LANDSCAPE PLAN - LOT 2,1-1

CLAREMONT BUSINESS PARK - 2  
FILING NO. 1, LOT 1  
7715 GARY WATSON POINT  
COLORADO SPRINGS, 80915  
EL PASO COUNTY, CO  
PREPARED FOR:  
HAMMERS CONSTRUCTION

JOB NUMBER	949-20
REVISIONS	
ORIGINAL DATE	9-8-20
DRAWN BY:	JM
DESCRIPTION:	LANDSCAPE PLAN
SHEET NO.	L1.1

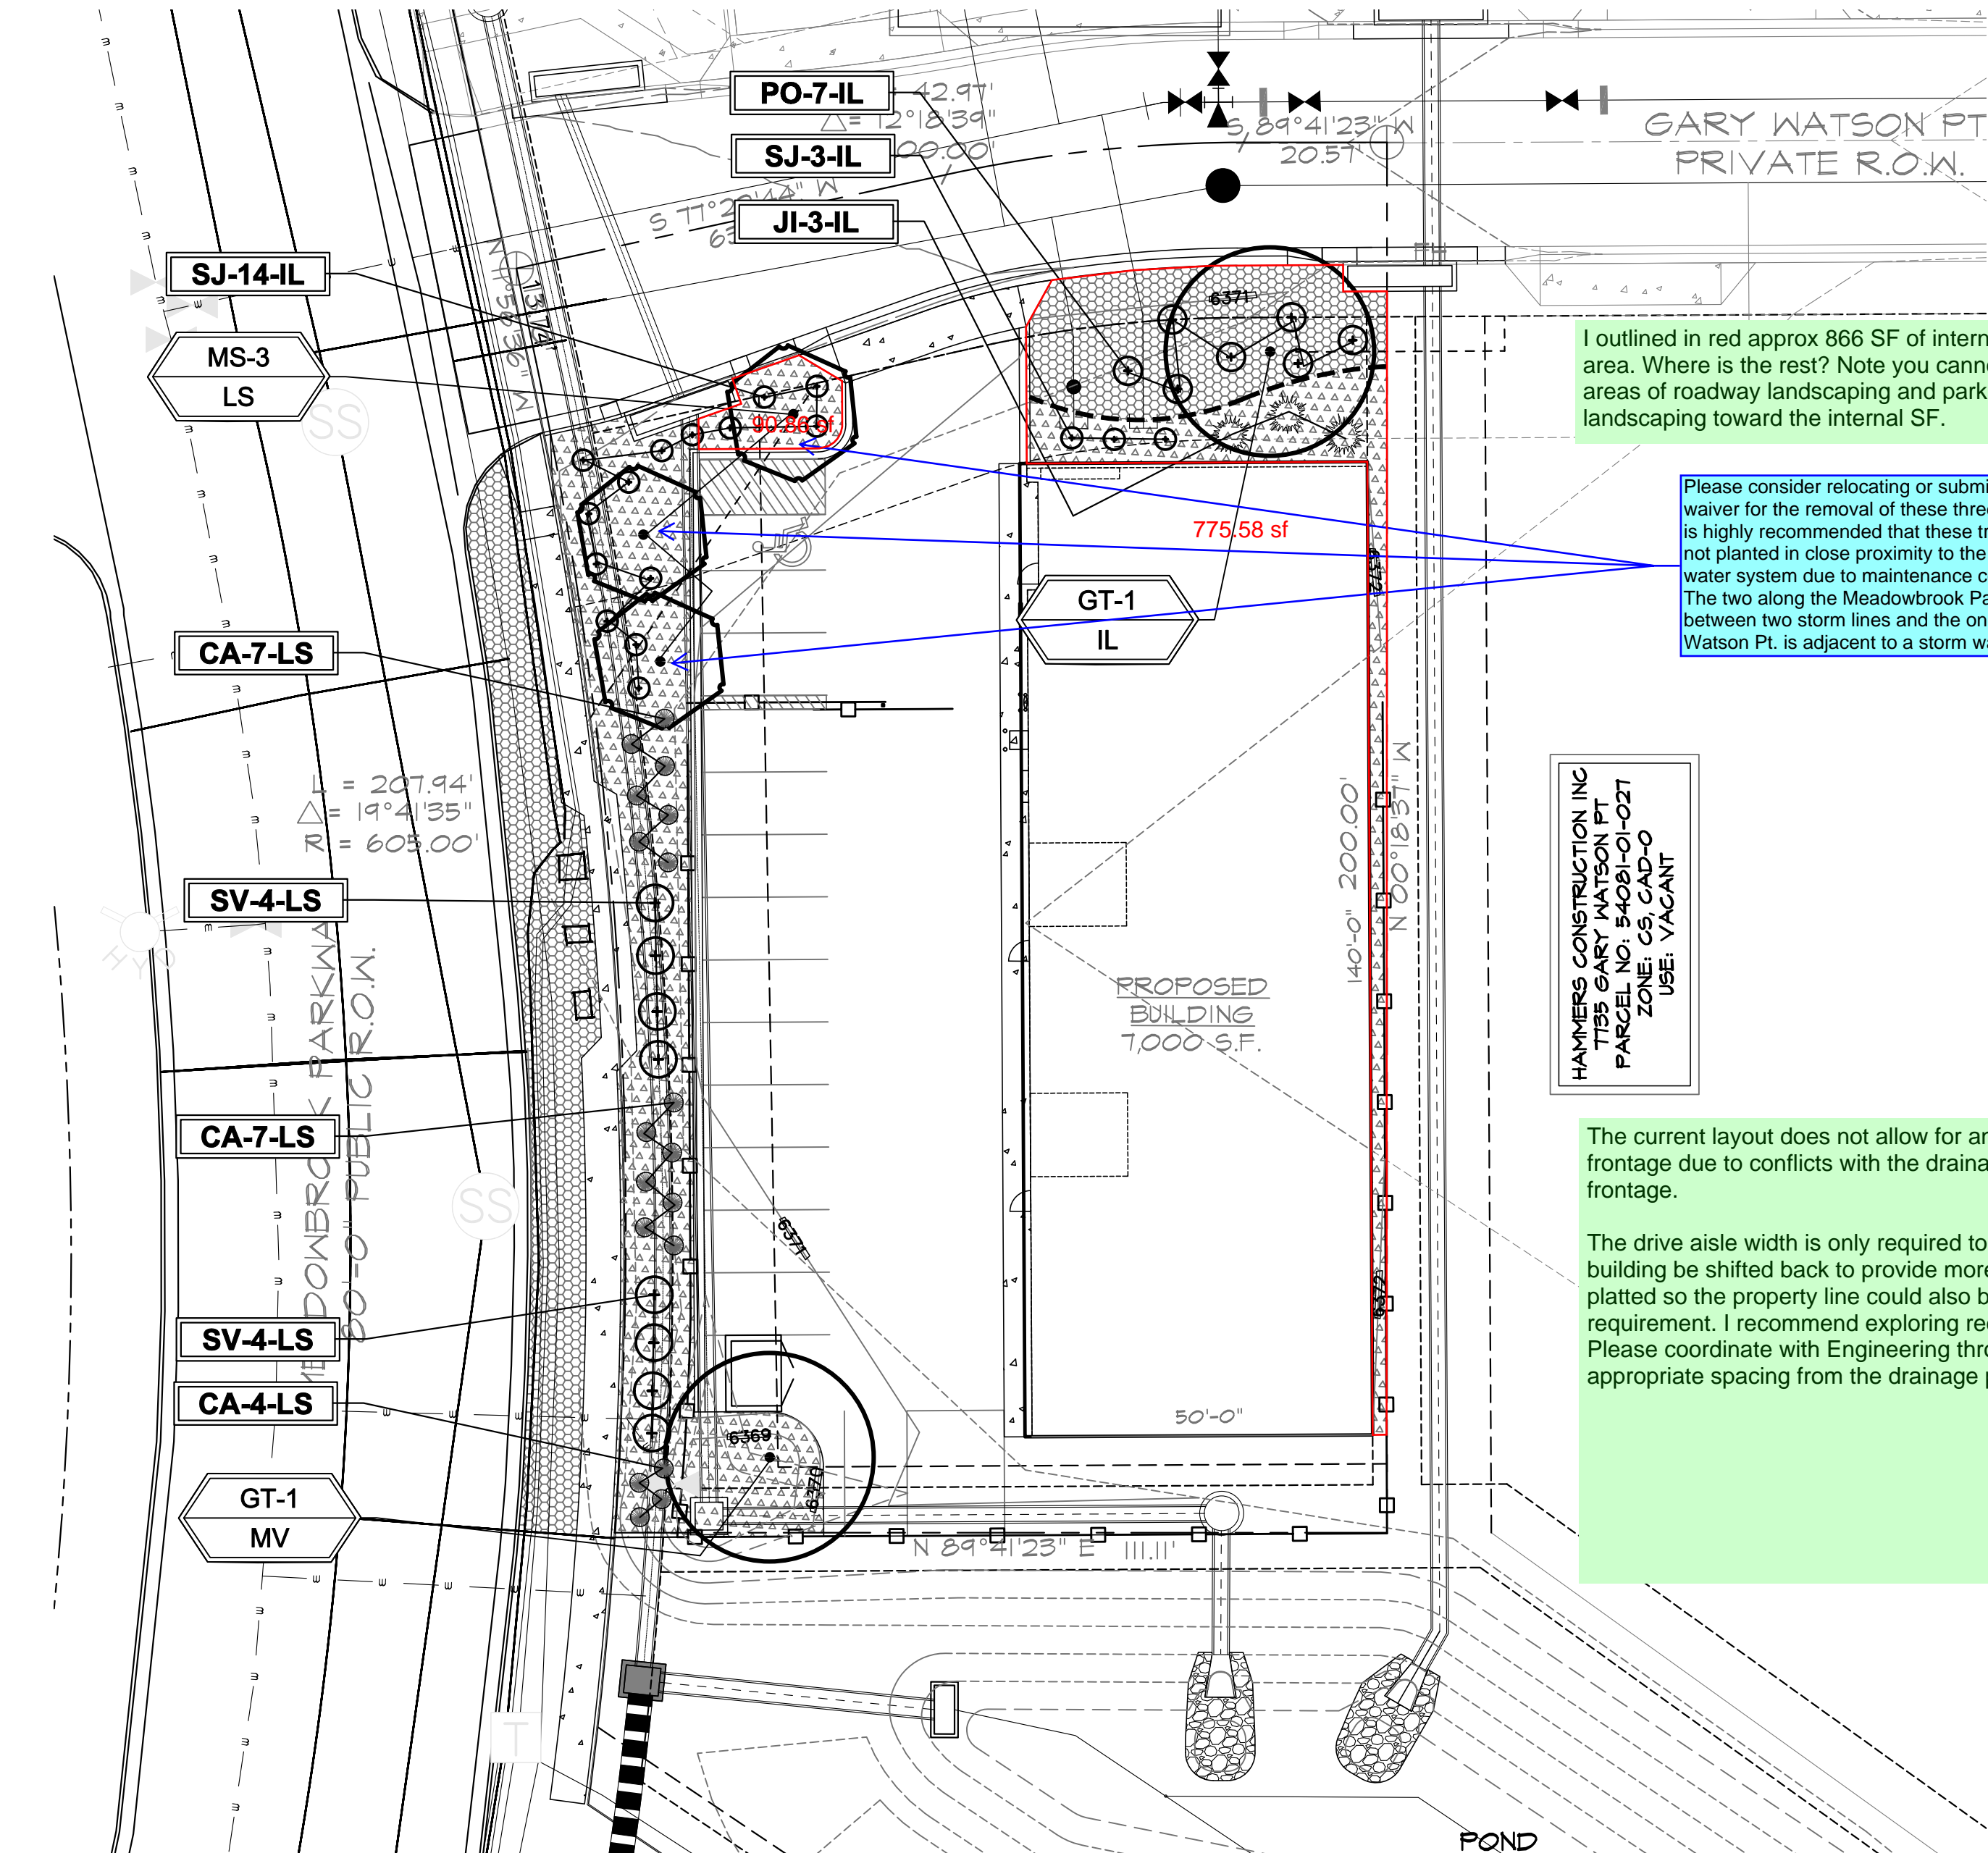
this reflects 5' spacing. Some of the species you have shown along that frontage do not spread that far to provide a continuous hedge at maturity

3 evergreen shrubs are shown on the plan schedule and none of those are depicted along the meadowbrook frontage which requires evergreen screening. You have indicated that 15 evergreen shrubs are proposed along that frontage and they are not present. Please provide for next submittal. Note that all parking lot screening shrubs shall mature at 3' minimum height.

Ensure all shrubs proposed for parking lot screening will meet the 3' min height requirement.

Ornamental grasses are not considered evergreen. They are usually sheared back each year and will not provide three foot minimum height required for parking lot screening.

1 outlined in red approx 866 SF of internal landscape area. Where is the rest? Note you cannot double count areas of roadway landscaping and parking lot landscaping toward the internal SF.

Please consider relocating or submitting a waiver for the removal of these three trees. It is highly recommended that these trees are not planted in close proximity to the storm water system due to maintenance concerns. The two along the Meadowbrook Parkway are between two storm lines and the one on Gary Watson Pt. is adjacent to a storm water inlet.

The current layout does not allow for any roadway landscape trees along the Meadowbrook frontage due to conflicts with the drainage easement and drainage pipe that runs along that frontage.

The drive aisle width is only required to be 24' wide and you provided 29' wide. Also could the building be shifted back to provide more space in front to fit the required trees? This lot is not yet platted so the property line could also be shifted to allow enough space for this lot to meet the requirement. I recommend exploring redesign options to provide the roadway landscaping. Please coordinate with Engineering through the process to ensure any redesign provides appropriate spacing from the drainage pipes.
